# UNITED STATES PATENT AND TRADEMARK OFFICE

APPLICATION NO.	FILING DATE	FIRST NAMED INVENTOR	ATTORNEY DOCKET NO.	CONFIRMATION NO.
10/085,649	02/26/2002	Andrew J. Whitton	091395-9214 (4596-TC-AU)	8642

## Office Action Summary

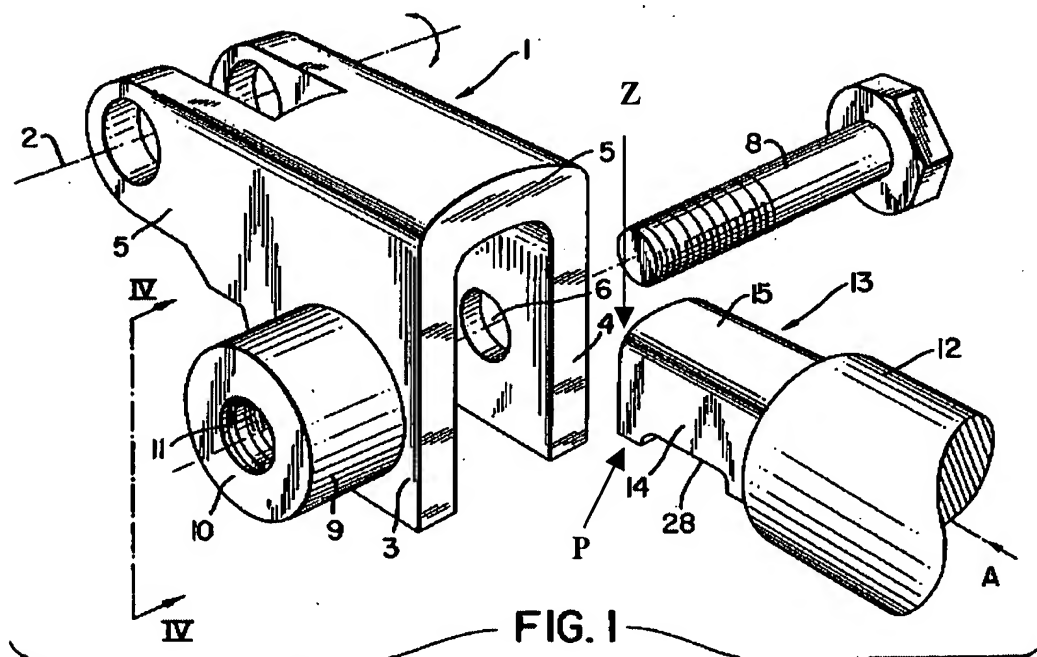
8. **Claims 1**, are rejected under 35 U.S.C. 102(b) as being anticipated by Oertle et al (US 5,090,833) (Oertle), cited in Applicant’s Information Disclosure Statement (paper no. 2).

a. Claim 1. Oertle shows and discloses a shaft **12** configured for interconnection with a coupling element **1**, the shaft **12** comprising an axial shaft body having upper and

lower surfaces and terminating in a forward end **Z**; a bolt receiving recess **28** in the upper shaft surface adjacent the forward shaft end **Z**; and the shaft body forward end **Z** having a substantially planar surface except for at least one projection **P** extending from the shaft forward end **Z**, the at least one projection **P** having an upper surface contiguous with the upper shaft surface and positioned completely within an upper hemisphere of the shaft body (see annotated figure 1 below).

- b. Claim 2. Oertle further shows the shaft body 12 having a given cross-sectional area and the projection **P** having a cross-sectional area substantially less than the shaft body 12 cross-sectional area (see annotated figure 1 above).
- c. Claim 9. Oertle shows a shaft coupling assembly comprising a coupling element 1 including a shaft-receiving slot (created inside element 5) having a bottom surface and

d. Claim 10. Oertle further shows the shaft-receiving slot having a given cross-sectional area, the shaft body 12 having a cross-sectional area (that of section 13 of the shaft 12) substantially equal to the shaft-receiving slot cross-sectional area and the projection P having a cross-sectional area substantially less than the shaft-receiving slot 9 cross-sectional area (see annotated figure 1 above).

- e. Claims 7 and 17. Oertle further shows the bolt receiving recess **28** being a notch (see annotated figure 1 above).
